Type of Survey ..... WIRE DRAG  
Field No. .... 40-1-76 R7H  
Office No..... H-9627 W.D.

State ..... Louisiana  
General Locality ..... Gulf of Mexico  
Locality ..... Vicinity of Calcasieu Pass

ATLANTIC MARINE CENTER  
VERIFIER'S REPORT/ADDENDUM TO THE DESCRIPTIVE REPORT

REGISTRY NO. H-9627 WD

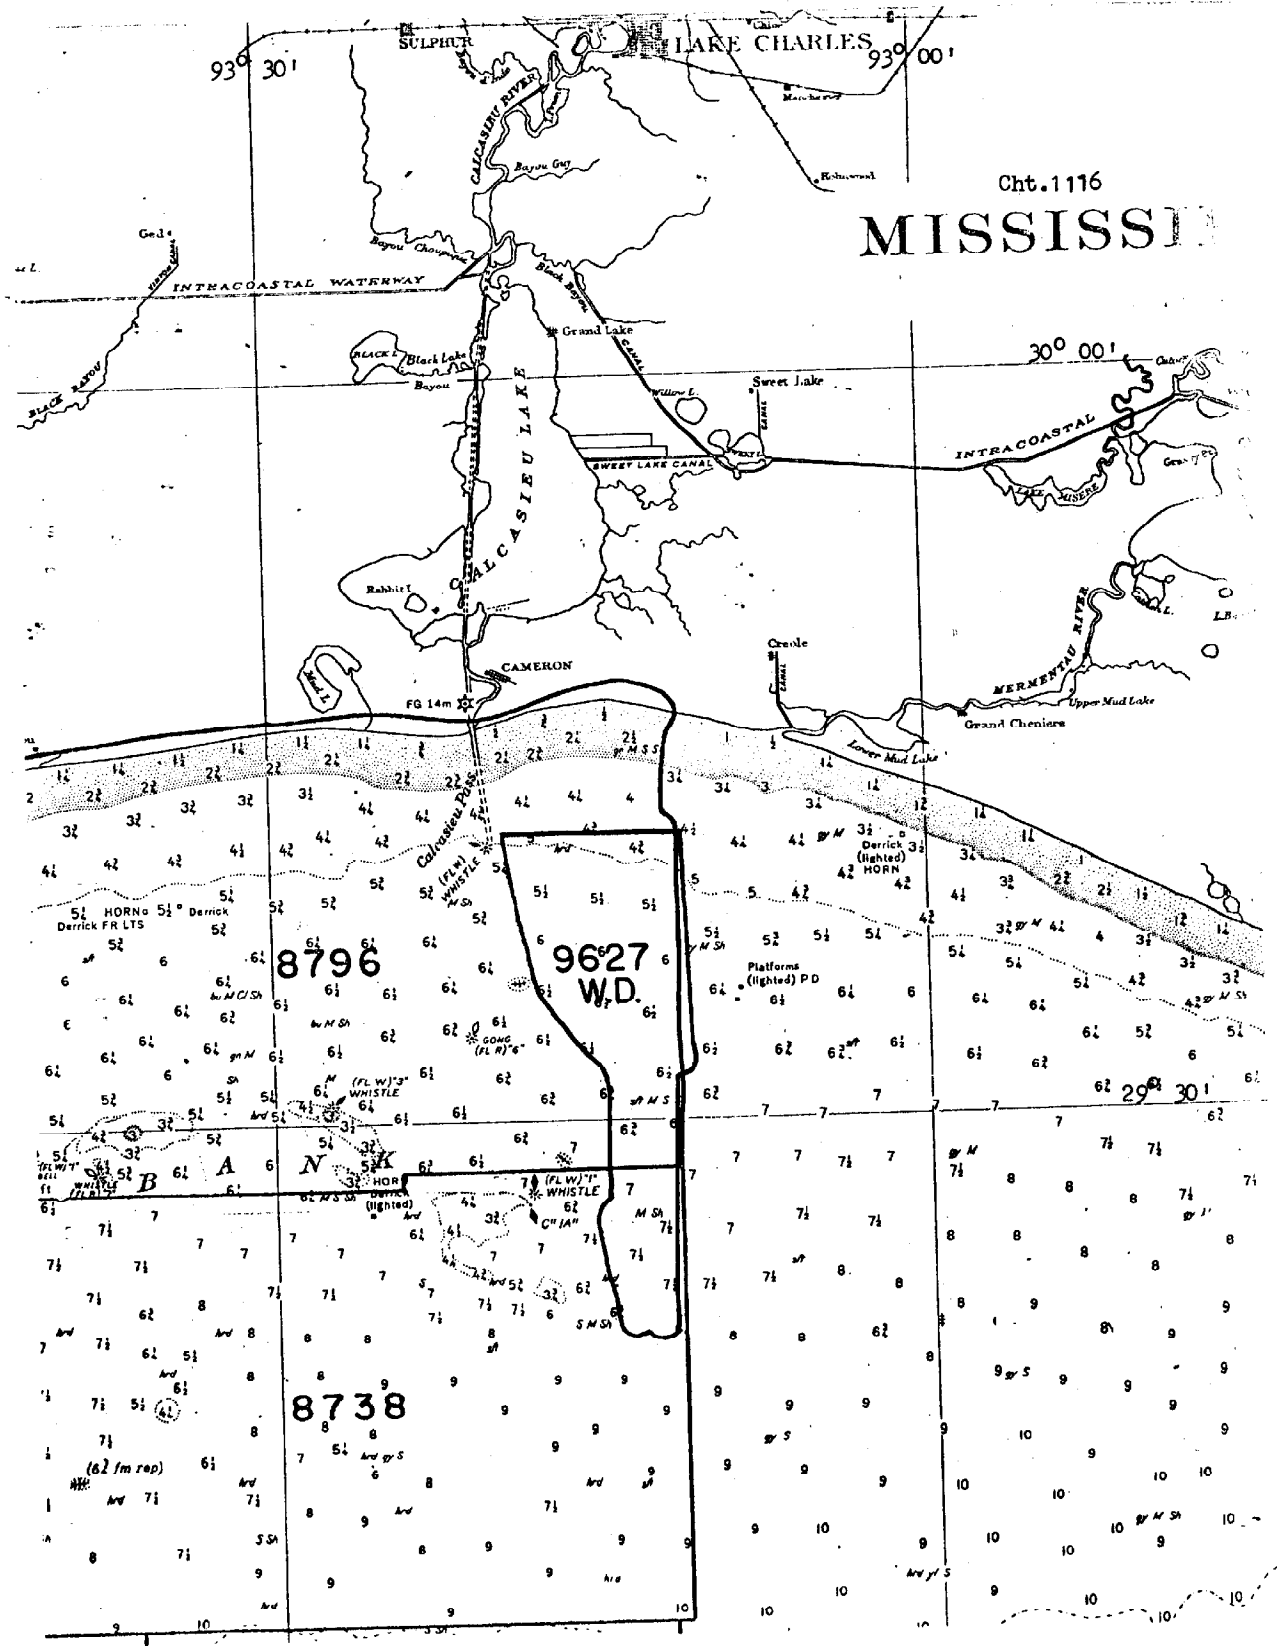
7. Section 9 of the Verifier's Report is supplemented by the following:

f. It appears that the hydrographer has adopted an unconventional practice regarding the voidance of portions of entire drag strips due to temporary hangs or groundings in any given section of the drag. Consequently, a portion of the voided areas on strips AD-3 and AL-1 resulted in smooth plotted splits in the vicinities of latitude  $29^{\circ}27.80'$ , longitude  $93^{\circ}14.64'$  and latitude  $29^{\circ}24.00'$ , longitude  $93^{\circ}13.70'$  respectively. The referenced drag strips were appropriately revised so as to effect valid clearances of the referenced splits.

The unconventional field practice is considered unnecessarily conservative and causes a loss of valid significant information. It is the customary practice to disclaim only the section of the drag in which the hang or grounding occurs. In addition, if the hang or grounding occurs at a particular buoy of the drag, then affected adjoining sections of the drag are customarily voided. It is recommended that the voiding of sections of drag strips be in conformance with the customary practice. Such customary practice is considered sufficiently conservative and will minimize the loss of valid information. In addition, it may tend to obviate the need for additional drag strips to cover isolated splits or areas of inadequate clearance.
